RE: Pre-application Review for **Category C Driveway**, Pre-application Meeting Date: **August 17, 2023**

**Right-in/Right-out access on the west side of SR 5 / N. Federal Highway, approximately 27 feet south of the north property line**

Project Name & Address: **El Car Wash Pompano Beach – 3685 N Federal Highway, Pompano Beach, Florida**  
Property Owner: **Kaja Properties Inc;** Parcel Size: **0.859 Acres**  
Development Size: **4902 SF One (1) Tunnel Automated Car Wash**

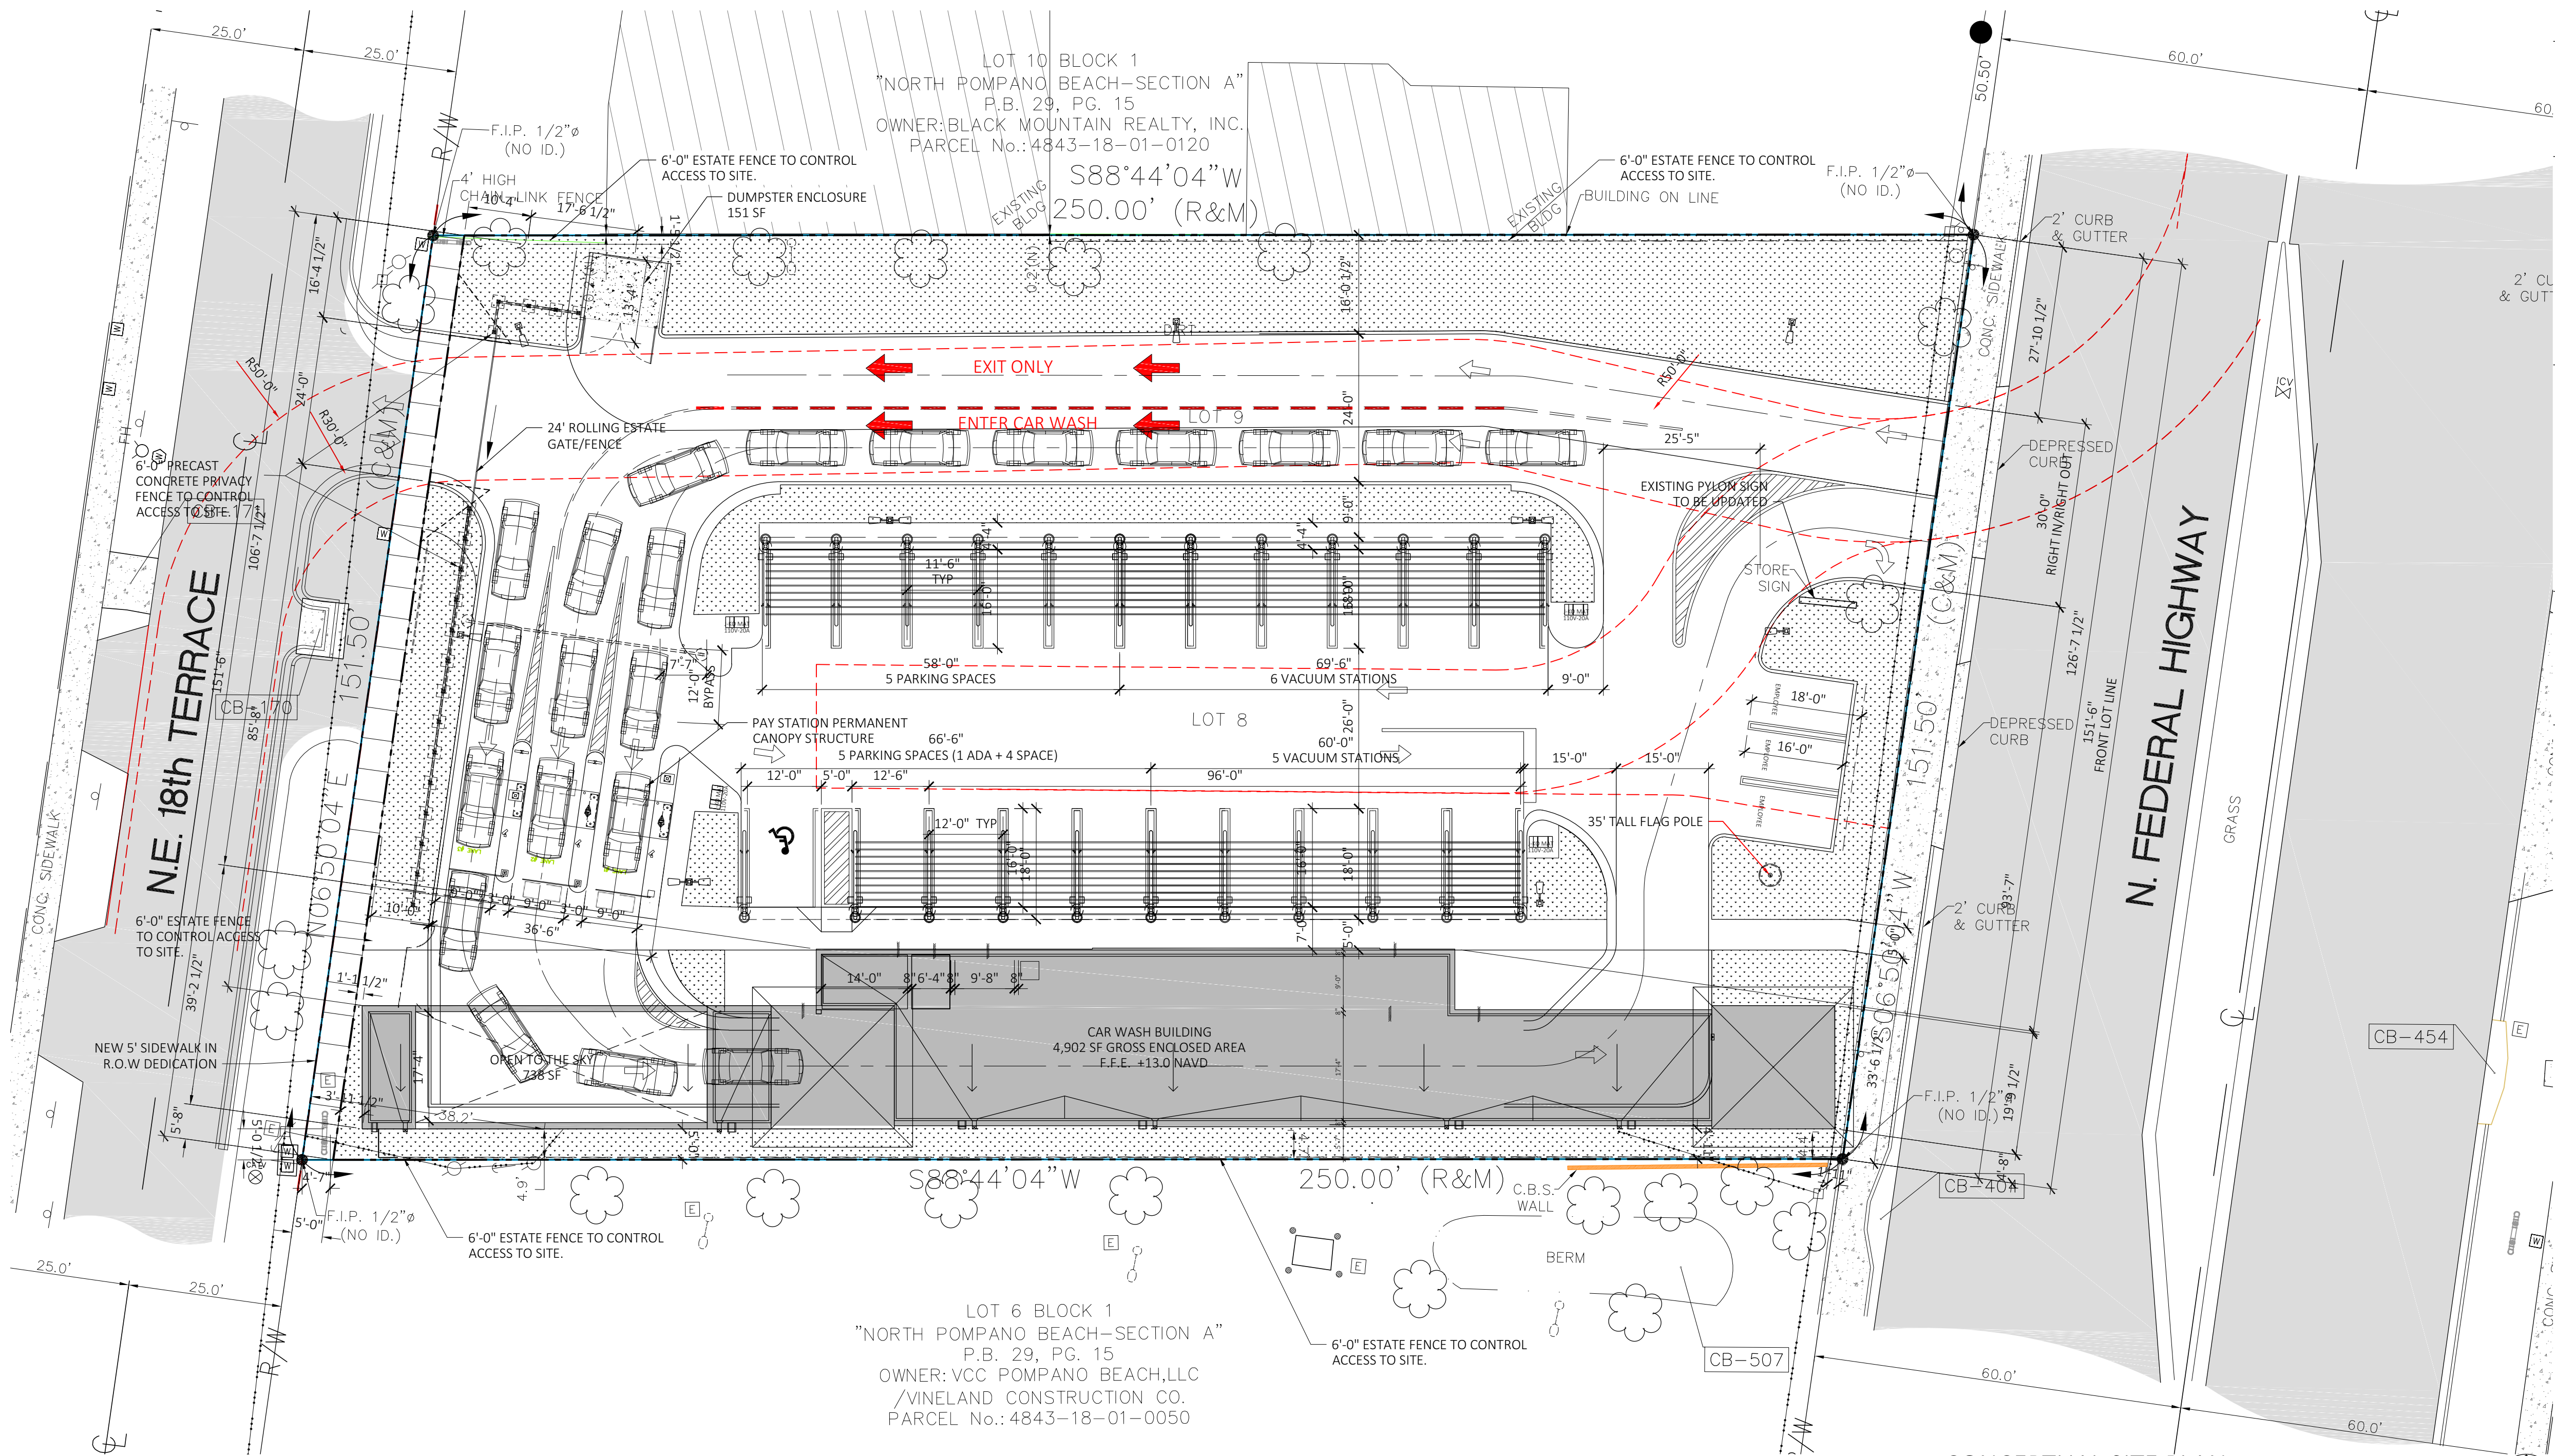
- **A minimum driveway length of 25 feet, as measured from the ultimate right-of-way line to the first conflict point shall be provided.**
- **If a gate is proposed, a minimum driveway length of 100 feet to the call box and/or gate house, and a turnaround area before the gate are required.**

- All driveways not approved in this letter must be fully removed and the area restored.
- A Drainage Permit is required for any stormwater impacts within FDOT right-of-way (i.e. increased runoff or reduction of existing storage).
- The applicant shall donate property to the Department if right-of-way dedication is required to implement the improvements.
- Dimensions between driveways are measured from the near edge of pavement to near edge of pavement and for median openings are measured from centerline to centerline unless otherwise indicated.
